## MEMORANDUM

**RE:** Phase I Permit Assistance: Calumet Reactor Perkins 409-000 Rev 02 Truck Configuration, Bridge Factor vs. Truck Factor Comparisons

**Figure 4**

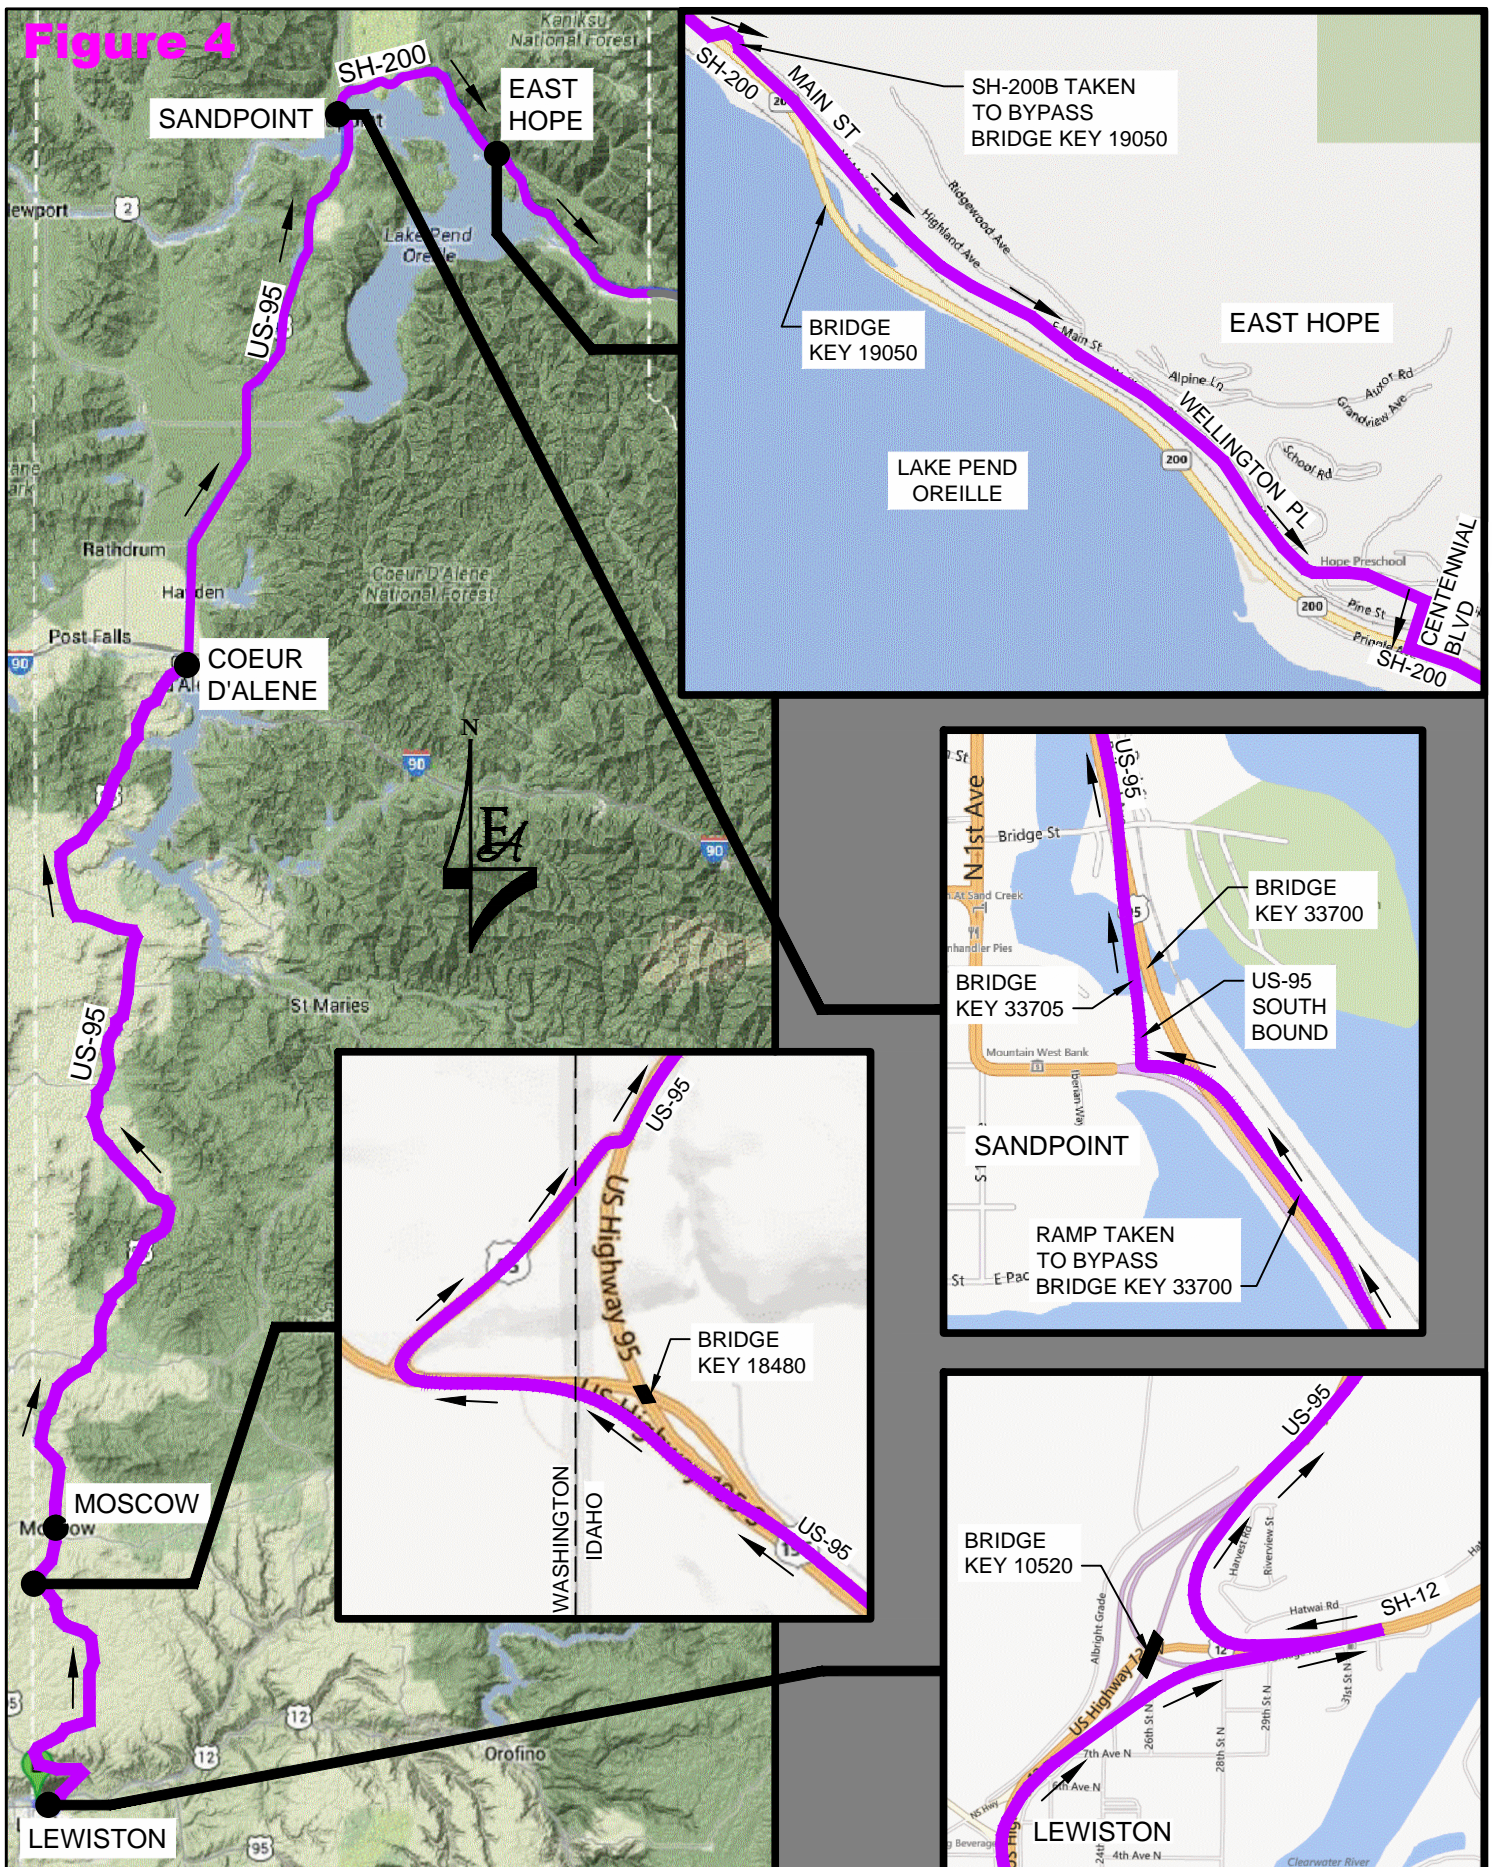
The route will begin at the Port of Lewiston and proceed on US-95 bypassing structures 10520 and 18480 (see Figure 4) and then continue on to Sandpoint. Just before Sandpoint the US-95 Northbound structure 33700 is bypassed using the southbound off-ramp structure 33705. The route will continue on US-95 to the SH-200 interchange and proceed east on SH-200. In order to bypass structure 19050 near Hope the SH-200 Business Loop will be taken. The truck configuration will return to, and remain on SH-200 until the Idaho/Montana border.
